Subject: Project Enhancement and Refinement Document
Carlsbad Energy Center Project (07-AFC-6)

Carlsbad Energy Center Project (07-AFC-6) Project Enhancement and Refinement Document

Submitted by
Carlsbad Energy Center LLC

July 2008

FIGURE 2.2-2B
CROSS-SECTIONS AND
ELEVATIONS
CECP POWER BLOCK
 CARLSBAD ENERGY CENTER PROJECT
 CARLSBAD, CA

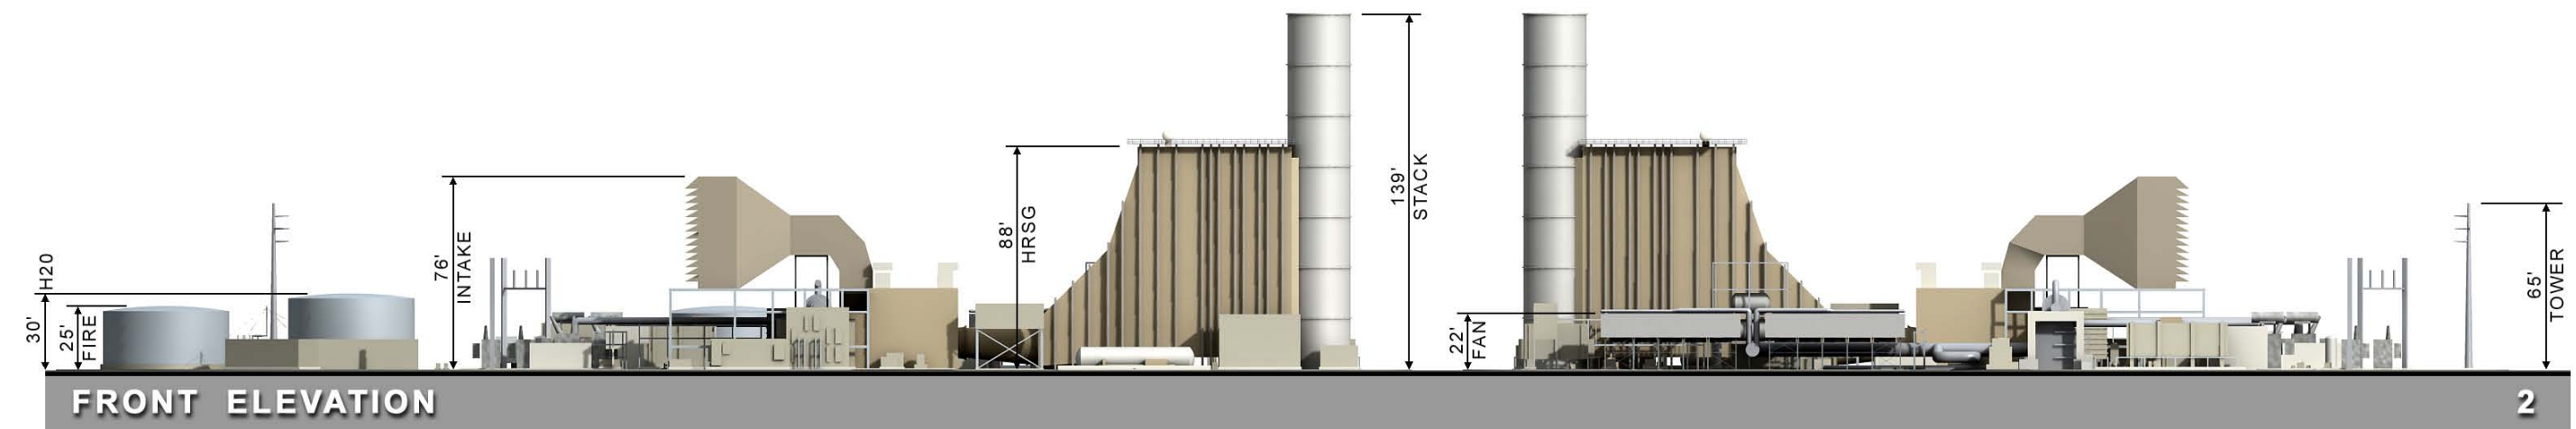
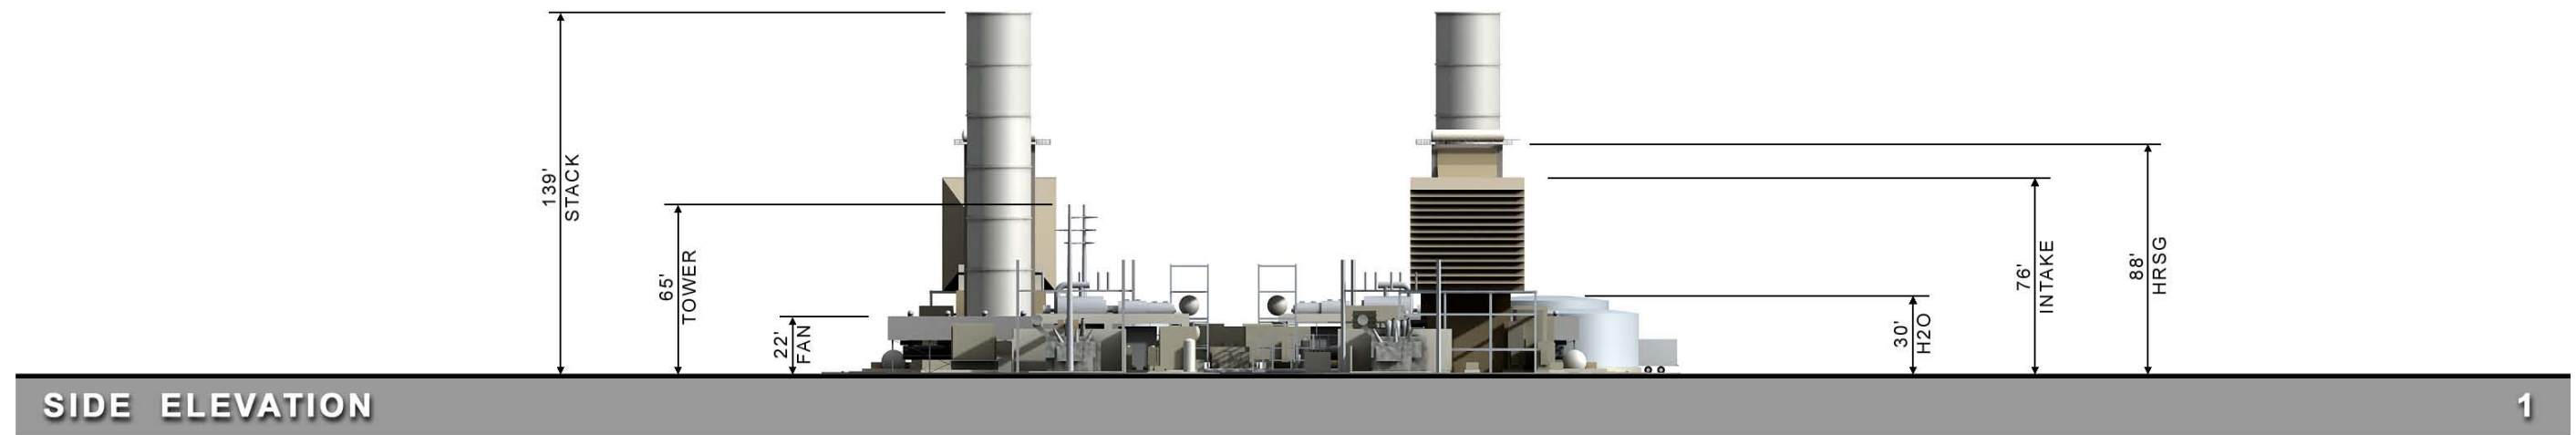
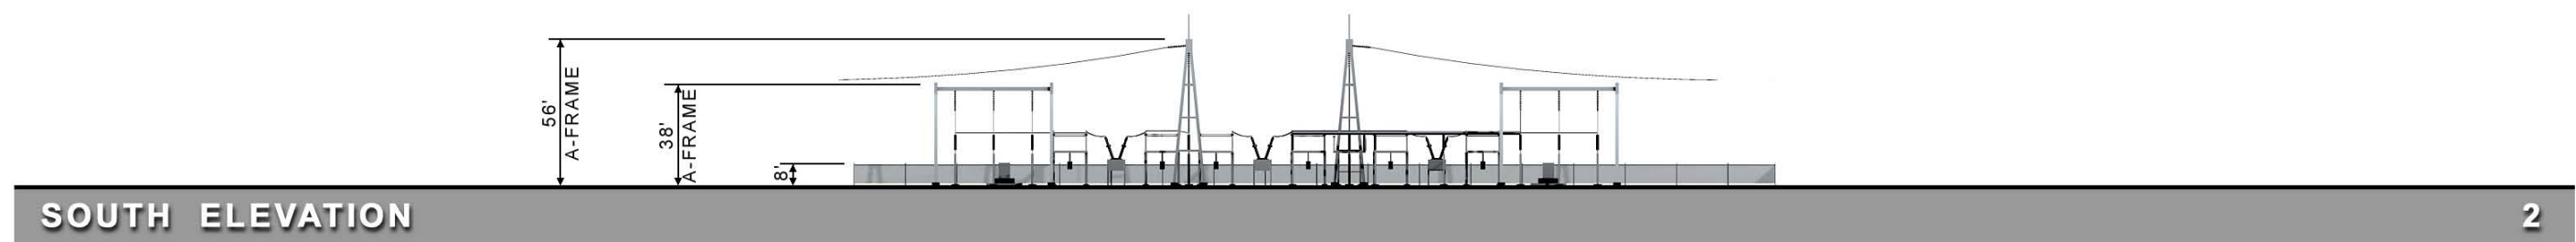
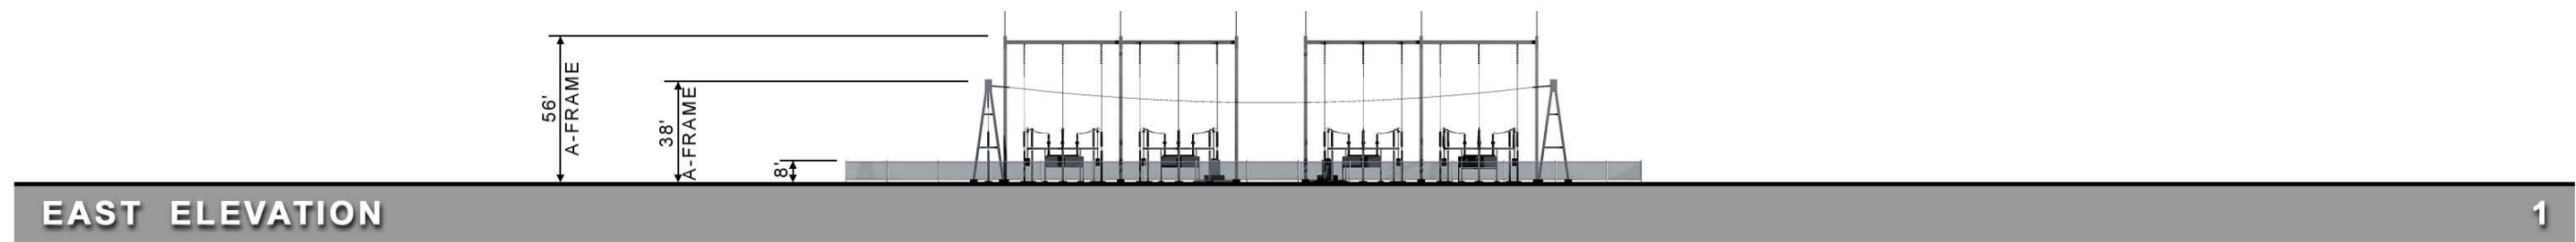
As noted, stack height is shown at 139 feet.

NEW FIGURE 2.3-1
EXISTING ENCINA TANK FARM
ENCINA POWER STATION
 CARLSBAD ENERGY CENTER PROJECT
 CARLSBAD, CALIFORNIA

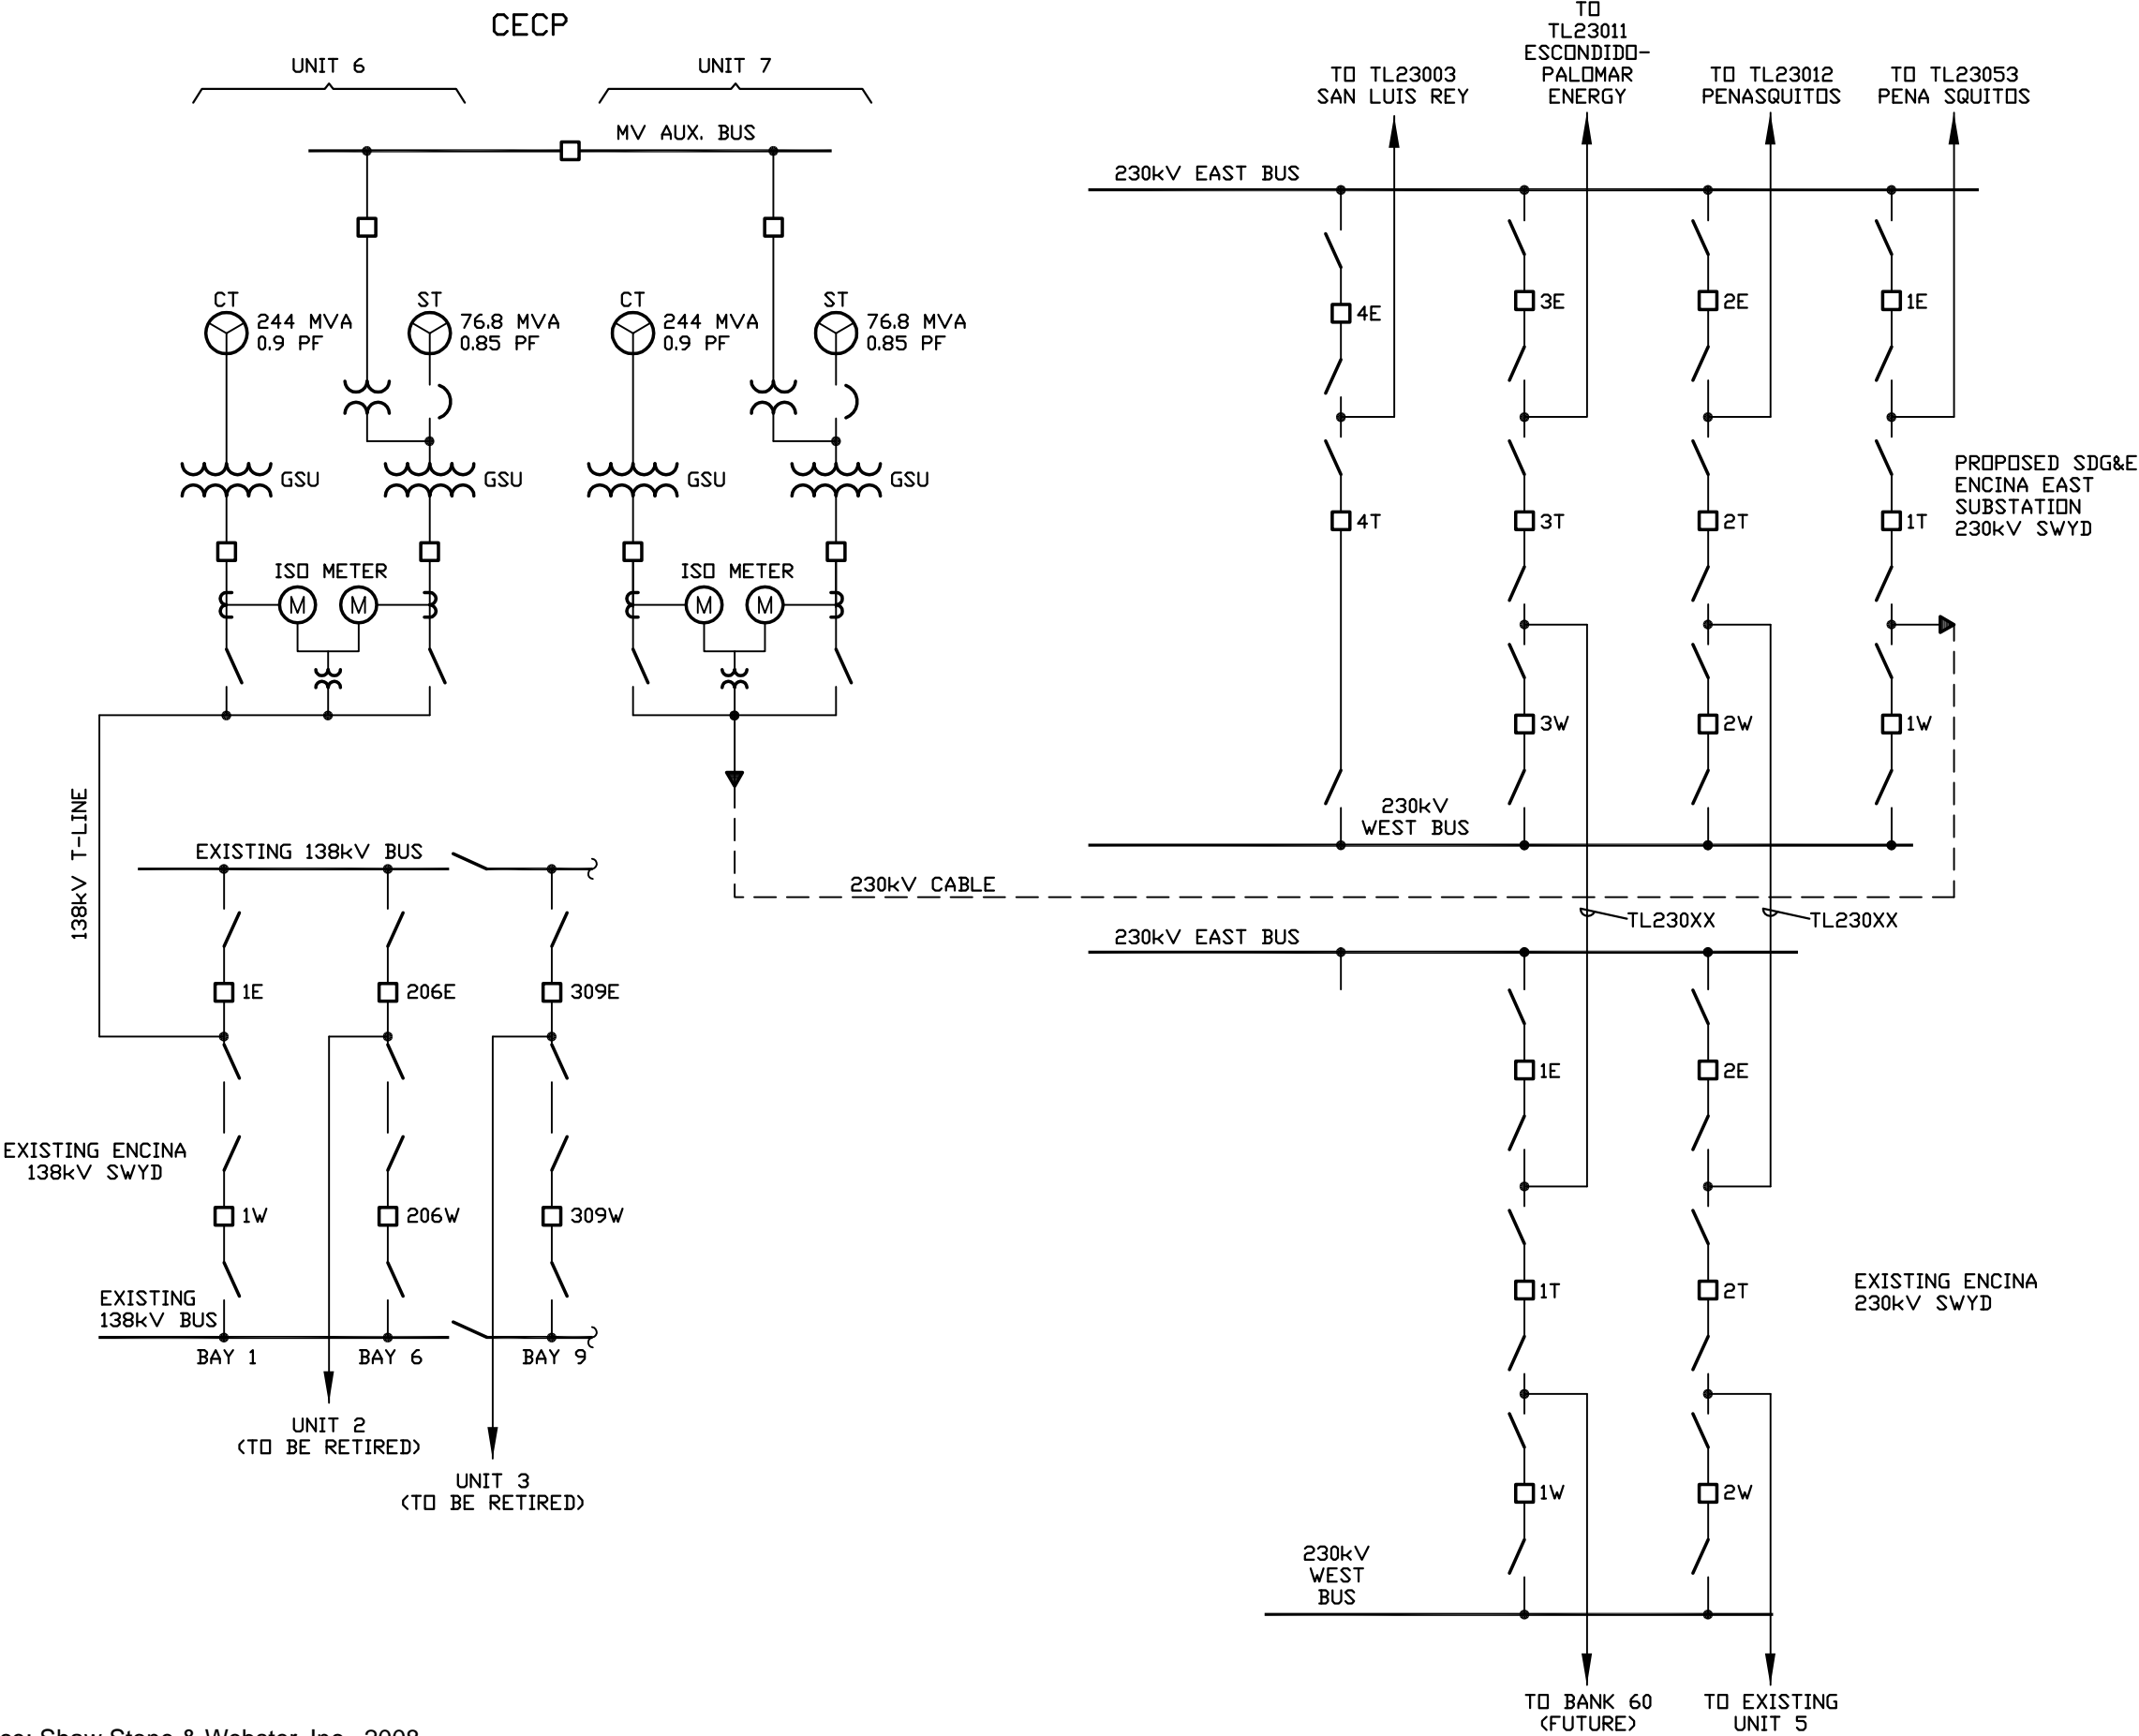
The East Tank Farm area is located in the northeastern portion of EPS property. This tank farm includes four No. 6 fuel-oil aboveground storage tanks (Tanks 4, 5, 6, and 7, as shown on New Figure 2.3-1). As part of the CECP, Tanks 5, 6, and 7 will be demolished, and soil remediation will be implemented after demolition. Tank 4 will continue to remain in service since it provides backup fuel oil for EPS Unit 4.

Tanks 5, 6, and 7 are located within impoundment basins and separated by concrete-coated earthen berms, as shown in New Figure 2.3-1. The top of the berms are at an elevation of approximately 54 feet above mean sea level. The berms are constructed at a 1.5 to 1 slope and are approximately 20 to 25 feet high from the bottom of the East Tank Farm impoundment. At the bottom of the each impoundment basin, the footprint of each tank is surrounded by a 6-inch layer of gravel. Dike drain sump structures, inlets, and 18-inch-diameter corrugated metal drainage pipes line the perimeter of each impoundment basin. A drain rock layer, 4-inches thick, overlays the bottom 15 feet of the slopes of the earthen berms. The slopes of the earthen berms and drain rock layer are covered with a 2-inch-thick layer of gunite, reinforced with 6 by 6 – 10/10 welded wire fabric. The top of each berm varies in width from 10 feet to 16 feet and is covered with 6 to 9 inches of compacted, crushed stone and topped with 3 inches of asphalt pavement.

REVISED FIGURE DR68-6
FUTURE COASTAL RAIL TRAIL
EXISTING VIEW AND VISUAL SIMULATION
 CARLSBAD ENERGY CENTER PROJECT

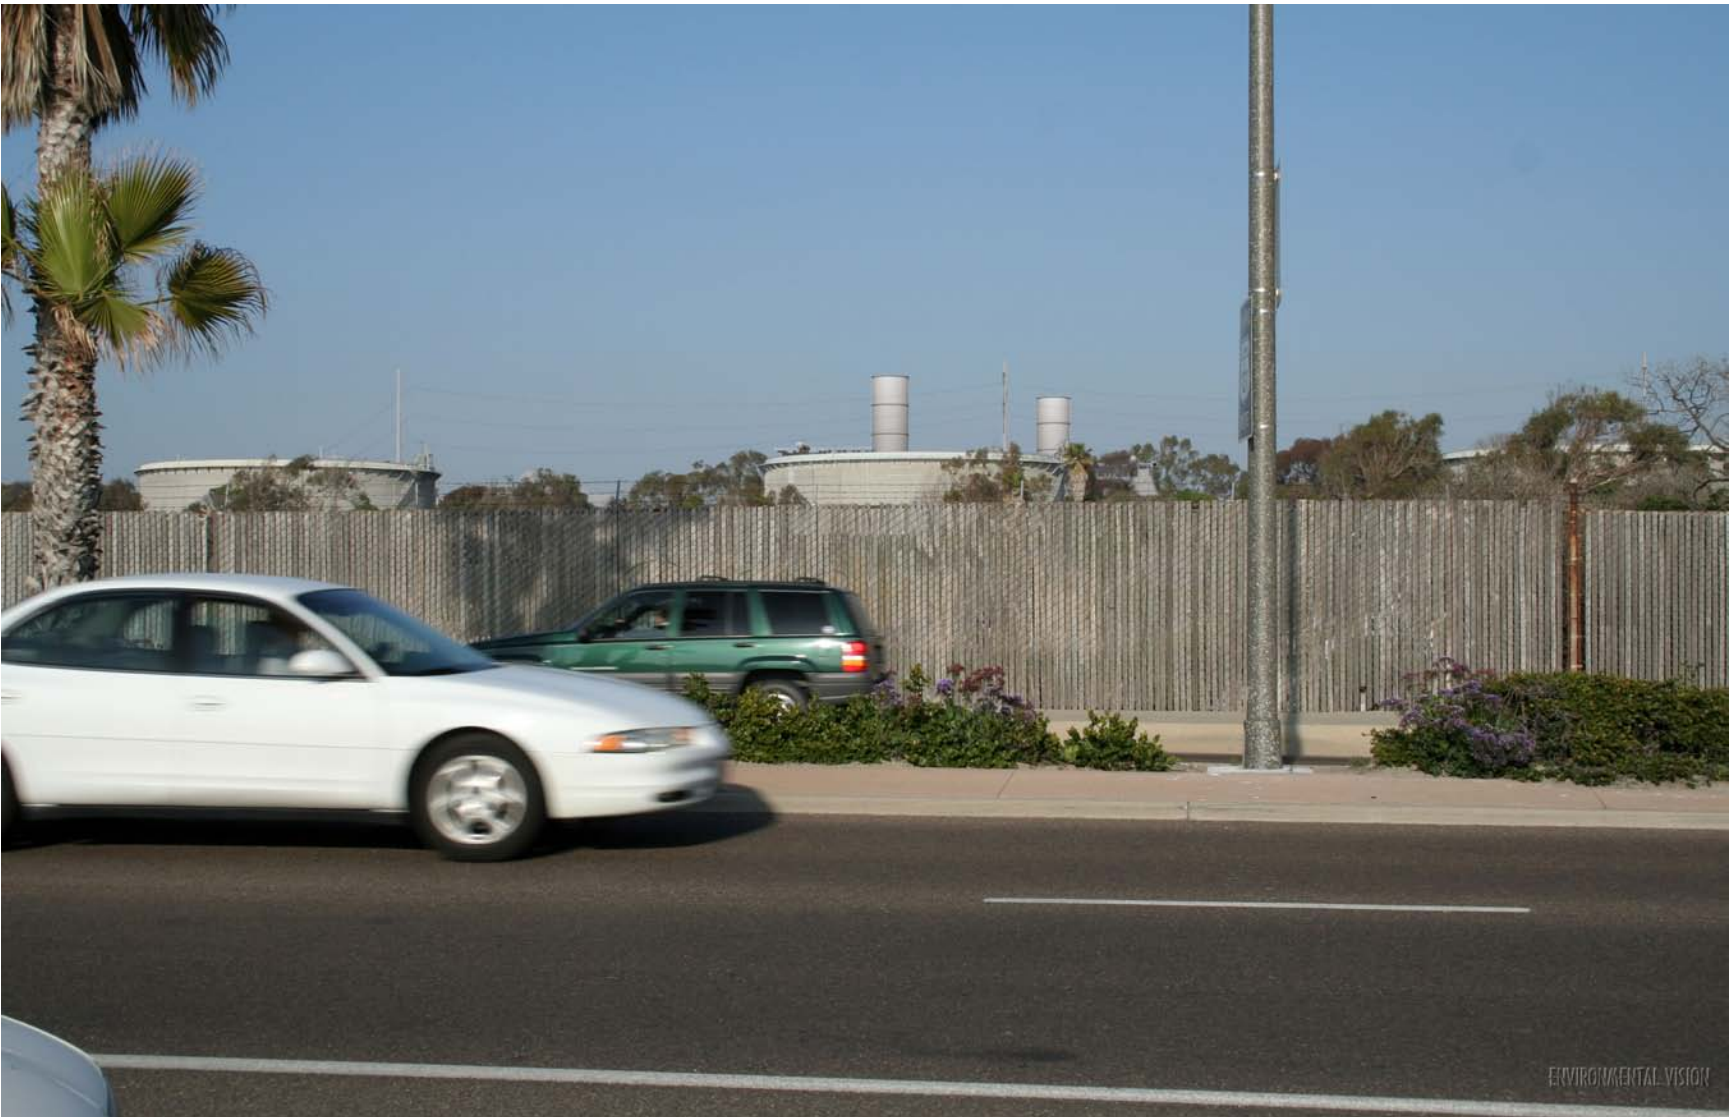
Stack height is shown at 139 feet
